**BID No. 25-26-18, Clerk's Office Expansion & Renovation**

**ADDENDUM #3**  
**April 27, 2026**

Addendum #3  
**San Juan County - Clerk's Office Addition & Renovation**

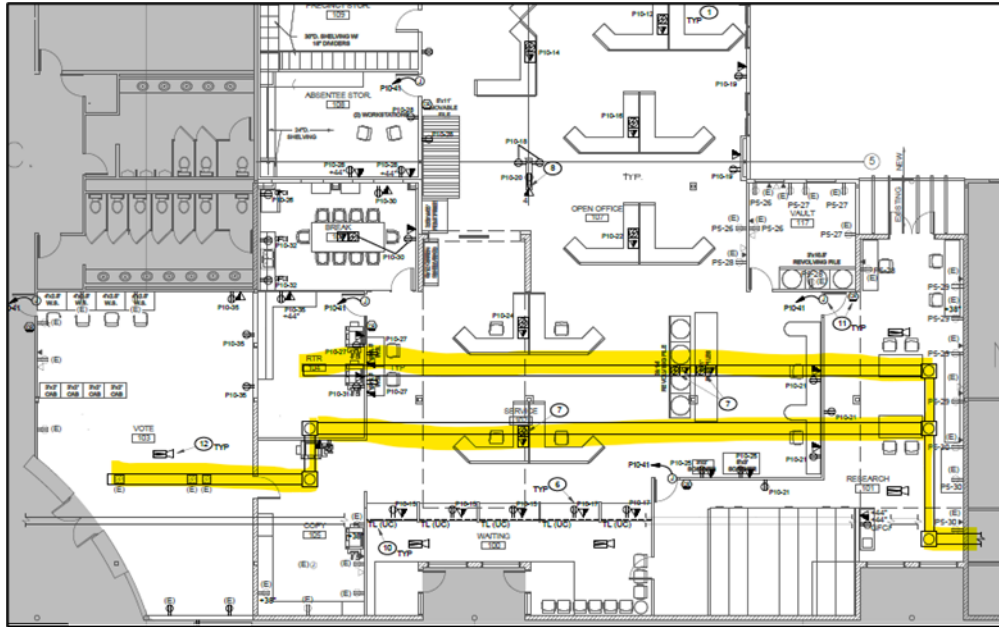
- Item #10: Sheet A6.3. Detail #1. The curb flashing shown may be 60 mil in lieu of the 80 mil shown.
- Item #11: Sheet E2.1 Clarification: The continuous outlined pathways in the existing building noted on the drawings represent and an existing underfloor duct system (see sketch below). Exact location of the underfloor duct shall be field verified by the Contractor. Contractor shall coordinate location of all new floor outlets with the owner and furniture layout prior to rough-in. Those outlets that align with the underfloor duct shall be installed per the manufacturer's recommendations. Should the floor outlets not align with the existing underfloor duct system then the contractor shall cut and patch existing floor slab to route the new conduits as required to the power source indicated.
